DEPARTMENT OF THE ARMY MODIFICATION WORK ORDER
DEPARTMENT OF THE NAVY

MWO 11-5895-833-30-3-2
EE060-BA-MWO-010/01658-MSC46 (V)

MODIFICATION OF
SYNTHESIZER, ELECTRICAL FREQUENCY

0-1658/MSC-46(V)

Figure 1. Warning Plate Location Diagram

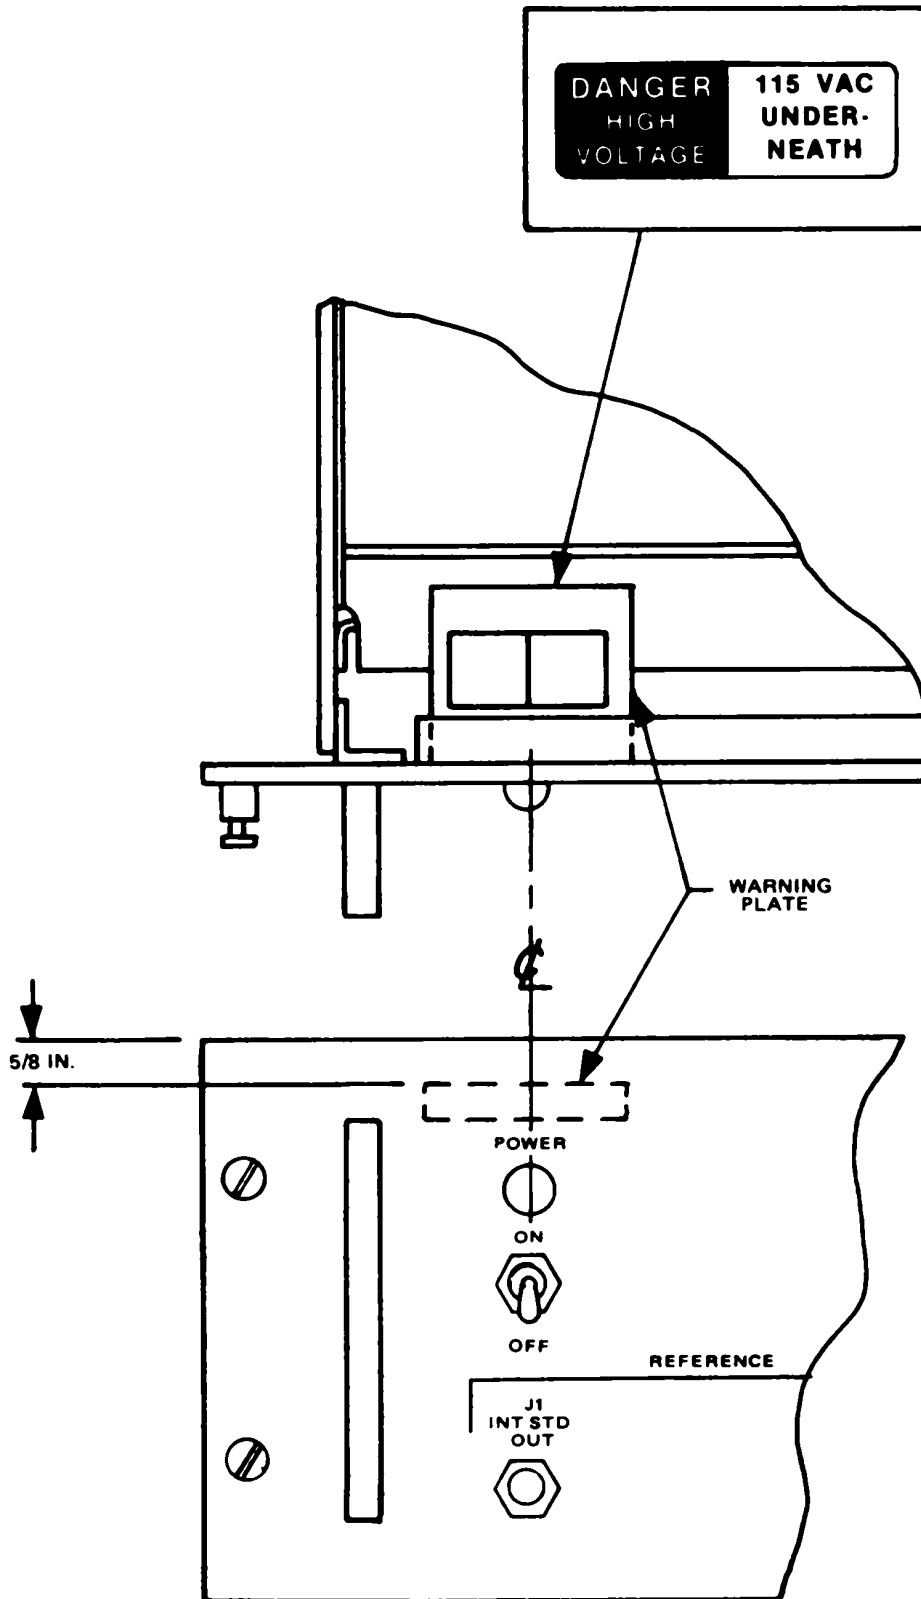
- (1) Set radio frequency synthesizer POWER switch to OFF.
- (2) Loosen four captive screws on front panel of electrical frequency synthesizer and pull chassis out until slides lock.
- (3) Remove all power connections from the rear of the synthesizer.
- (4) Remove all screws securing top cover plate and retain for later use.
- (5) Remove top cover plate and place it aside.
- (6) Release the two locking detents on slides and tilt chassis down.
- (7) Locate the area on the back side of the front panel above the POWER lamp and below the angle flange secured to the front panel. See figure 1. Clean this area, with solvent 1040017601(kit furnished), to remove grease, oil,

wax and other foreign substances. The area cleaned should be 2-1/2 inches wide, 5/8 inch below top of front panel and centered over the POWER lamp.

(8) Obtain from the modification kit one warning plate 2350021073-1 with warning label and extra fast setting epoxy.

(9) Position warning plate 2350021073-1 at the cleaned area centered over the POWER lamp, such that the warning label faces up and is readable from the front panel and that the 1/2-inch surface of the warning plate is against the back of the front panel.

(10) Read the instructions on the extra fast setting epoxy package, mix accordingly and apply the epoxy to the 1/2-inch surface of the warning plate. Install the warning plate in the position established in step (9), affixing the plate to the cleaned area at the back side of the front panel. Hold in place for two minutes.
